**Figure 1  
Basic standard area**

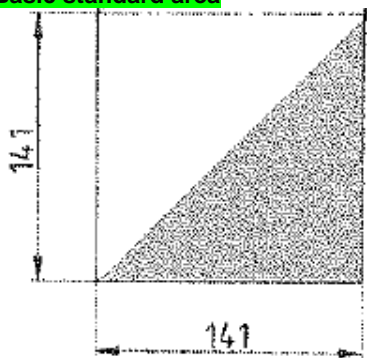
| 1               | 2   | (3)  | 4                            | 5  | (6)   | (7)  |
|-----------------|---|--|------------------------------|--|---|--|
| CEMA            | <b>Annex 6</b>                              |  | Te/ed                        | <b>Figure 1 and 2</b>  | <b>Delete; is in R70 and R104</b>   | See IWG AVLI above.                                |
